Comments on the Justification for the Lower Churchill Transmission Project (Labrador-Island Transmission Link)

submitted to the
Canadian Environmental Assessment Agency
Comprehensive Study on the Lower Churchill
Transmission Project

on behalf of Grand Riverkeeper Labrador Inc.

Philip Raphals
Executive Director
Helios Centre

CDM Program Funding

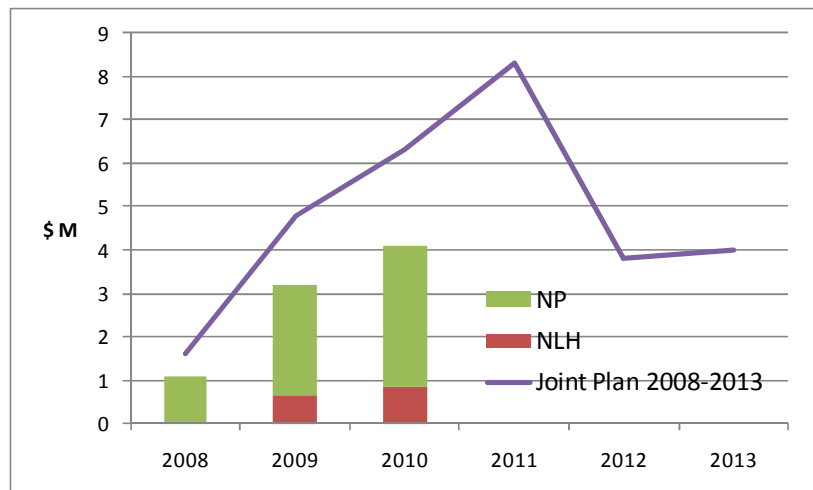
The following chart, drawn from my April 13, 2011 submission to the Joint Review Panel,²² demonstrates that CDM funding by NLH and by NP lagged far behind that which was projected in their Five-Year Joint CDM Plan.

This is not particularly surprising: Most utilities perform very poorly when they first begin to pursue CDM savings. What is surprising is that, based on its admittedly poor performance in the first years of its CDM program, **NLH has chosen to exclude consideration of CDM savings as a resource in its 50-year power plan.** I am not aware of any other utility in North America that has so blatantly disregarded CDM as a resource.

LIVE CHARTS - CRUDE OIL CHART AND LIVE OIL PRICES

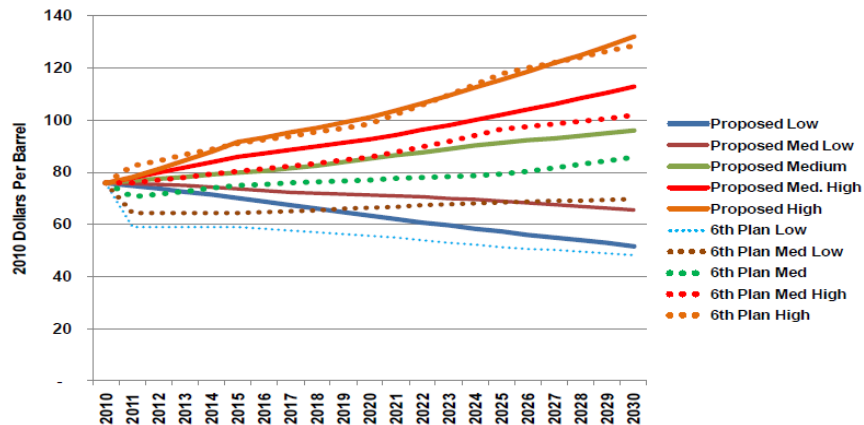
MHI pointed out this uncertainty as well, writing:

It is clear there is much uncertainty related to the pricing of fuel for thermal-based power generation. Different scenarios can and should be run and compared, but **the results related thereto often have a short shelf life.** While the prospect of raising the necessary capital to finance and construct the Infeed Option may be daunting, **the uncertainty associated with forecasting the price of fuel for thermal generation over the long term might be, and likely is, even more so.** (emphasis added)⁶³
